RENESAS TECHNICAL UPDATE

Product Category	MPU/MCU		Document No.	TN-RX*-A0267A/E	Rev.	1.00
Title	Addition of the Sub-section on Rewriting Flash Memory When Using Dual Mode		Information Category	Technical Notification		
Applicable Product	RX26T Group, RX65N Group, RX651 Group, RX66N Group, RX671 Group, RX72M Group, RX72N Group	Lot No.	Reference Document	User's Manual: Hardware for the applicable products listed in the table on the next page		
		All

Figure 1 Example of Rewriting Flash Memory in Linear Mode

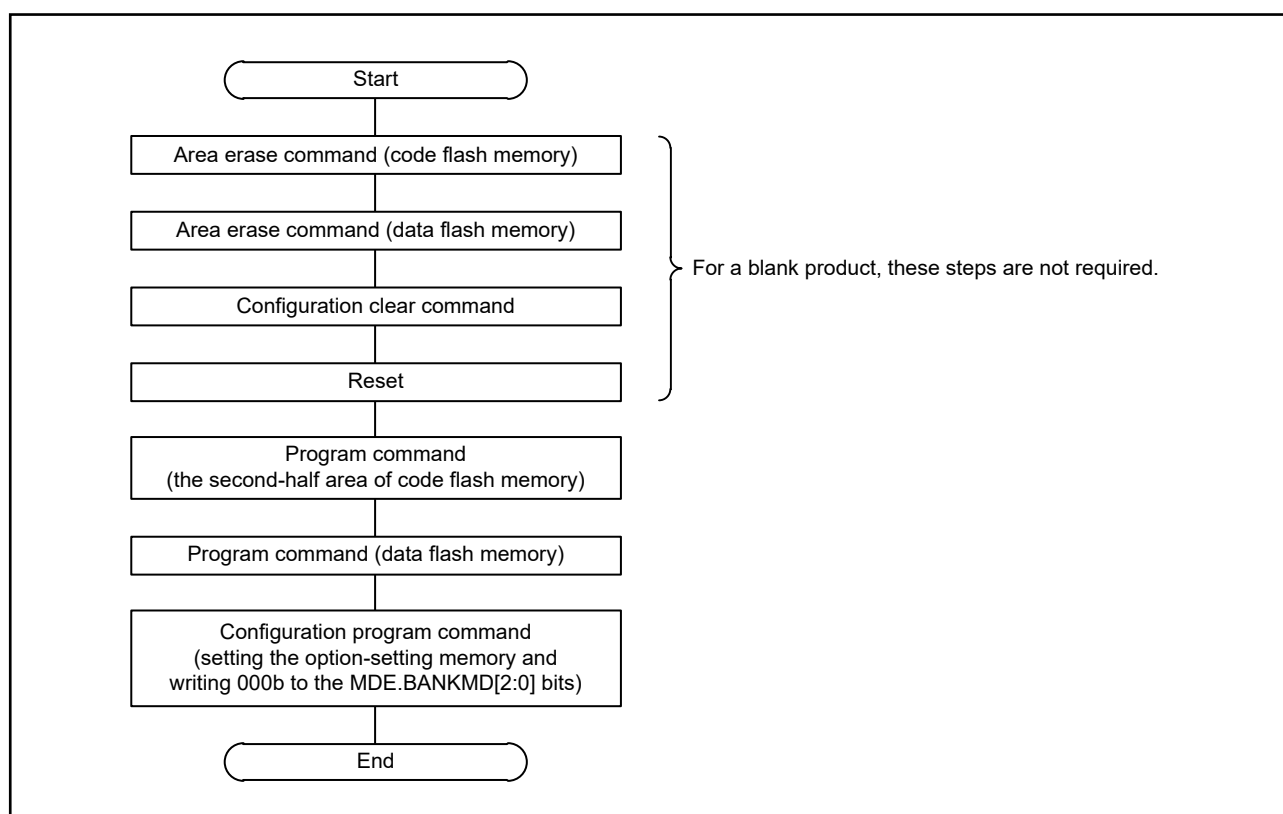
This document is a notification of the addition of an explanation of rewriting flash memory in linear mode to the sub-section on rewriting flash memory when using dual mode for the above applicable products.

Figure 1 shows an example of rewriting flash memory in linear mode.
